MEMORANDUM

TITLE: PUBLIC HEARING regarding a Subdivision Permit & Plat for Pee-Wee Ponderosa Subdivision, Located in a Portion of the NW¹/₄ of Section 29, Township 15 North, Range 63 West of the 6th P.M., Laramie County, WY.

Permit Number: PZ-24-00106

PEE-WEE PONDEROSA

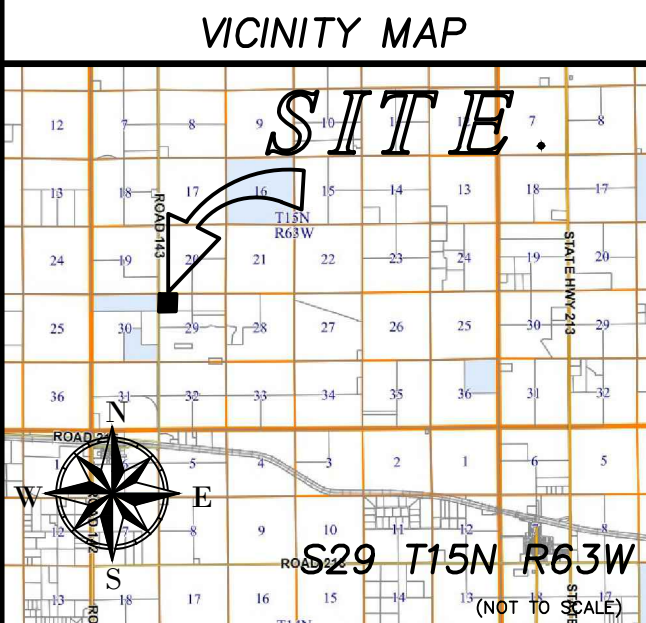
Agency reviews are still ongoing as of the date of this report. To date, they have addressed correcting the legal owner of the subdivision, the potential dedication of new ROW along the southern portion of the plat, and concerns with the spacing of access points along Road 143, which has a posted speed limit of 55mph. As currently proposed, the plat violates the required spacing for the posted speed limit and will need to be revised in order to become compliant with the LCLUR rules on spacing. As such, a recommended condition of approval accompanies the motion at the end of this report. Planning also recommends that the southern portion of the plat *not* dedicate new ROW along that portion given the private access easement’s location within the land to be dedicated. Rather, the suggestion would be to dedicate 40’ of ROW along the *north* portion of the plat, given its location along a Section line and long-range potential for future extension of Road 217.

- a. This application is in conformance with section 4-2-112 governing the LU – Land Use zone district.
- b. This application meets the criteria for a subdivision permit and plat pursuant to section 2-1-101 (a-e) of the Laramie County Land Use Regulations.
- c. The plat is currently noncompliant with access spacing requirements of LCLUR § 3-5-107.
- d. Plats have traditionally dedicated new ROW along section lines.

Surveyor Review
 1. Is the 80 ACCESS AND UTILITY EASEMENT along the south boundary of TRACT 4 (BOOK 1469 PAGE 963) dedicated to the public?
 2. Is ROAD 143 an official Laramie County Road created according to statutory requirements? If so, including the PETITION NUMBER for the road on the plat would clarify its status.

1. The plat is revised to make access spacing on Road 143 compliant with the LCLUR.
2. The plat is revised to move the ROW dedication to the north border rather than the south.

- 1. it doesn't appear to be
- 2. question for laramie county.
